- **MIRRORS—OUTSIDE REAR VIEW—RATTLE OR VIBRATION**
- **NOISE—“RATTLE” OR VIBRATION FROM OUTSIDE REAR VIEW MIRRORS**

**Article No.
91-10-3**

MERCURY: 1991 CAPRI

Figure 1 - Article 91-10-3

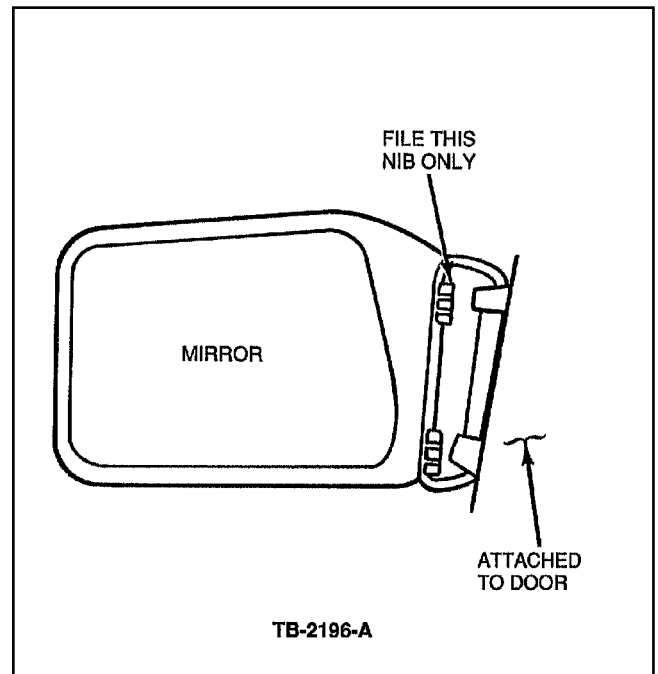
The outside rear view mirrors may rattle or vibrate. This occurs because the upper part of the rear location “nibs” do not allow a flush fit.

1. Inspect the mirror assembly by lightly pulling on the mirror head to see if it wobbles.
2. If the mirror head wobbles, pull the mirror head forward to expose the location “nibs”, Figure 1.
3. File the upper part of the rear location nib until the wobble is no longer apparent.

Modify the location “nibs” to permit a better fit. Refer to the following procedure for service details.

DO NOT REMOVE THE COMPLETE “NIB”. BE SURE THAT ONLY THE UPPER PART OF THE “NIB” IS FILED. TAKE CARE TO PROTECT THE MIRROR SURFACE FROM SCRATCHES.
